HISTORIC PRESERVATION COMMISSION

ALTERATION TO A HISTORIC PROPERTY STAFF REPORT

Site: 88 College Avenue c.1890 Charles H. Lockhart House Case: HPC 2015.005 Westwood Road Local Historic District

Legal Notice: Remove and replace siding, windows, and roof; alter rear deck.

Existing back deck and front porch showing baluster style.

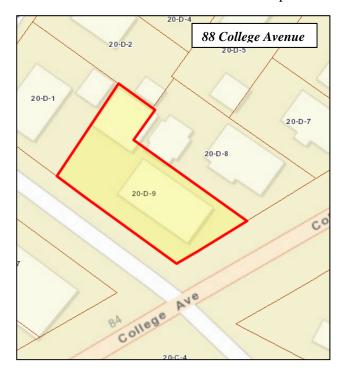
- 4. Remove back porch and construct a larger deck. See plans attached below. Porches are subject to greater damage from the weather than other portions of a house and are therefore regularly rebuilt. Rear porches in particular alter over time to meet changing needs. Altering the rear porch will not significantly alter the house and its inherent integrity. The proposed porch will have railings and balusters to match those on the front.
- 5. Replace rear door with a more appropriate one.

The existing rear porch is not original to the building. The new design is based on existing features of the front porch, duplicating the curved balusters. The newels will be simplified but will not be seen at the same time as those on the front.

- 5. The back porch shall be removed and replaced with a larger deck per plans received and stamped on January 28, 2014.
- 6. The rear door shall be replaced with a Simpson F-117 door.
